Preliminary review - additional review required
 Reviewed by: malcuran
 07/10/2024 12:12:32 PM

10090 OTERO AVENUE
 Legal: LOT M, VAC W 20.0 FT OF OTERO AVE, BLK B SPRING CREST FIL 2
 Area: 115,869 sq ft 2.66 ACRES
 Schedule #: 5124004009
 Zoning: RR-2 (equivalent RR 2.5)
 Owner: MARY AND CHARLES DE LAY
 Mailing: 10090 OTERO AVE COLORADO SPRINGS CO, 80920-1537

SITE PLAN
 SCALE: 1" = 20'-0"

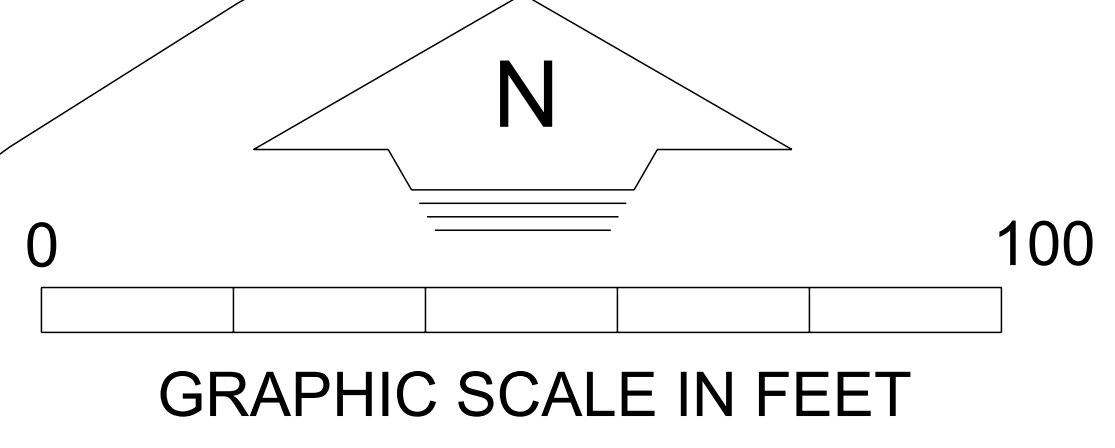
Show and label all existing proposed utility service lines with diameter, material, and either Public and/or private.

Show and label existing 1" gas service line CSU #121703
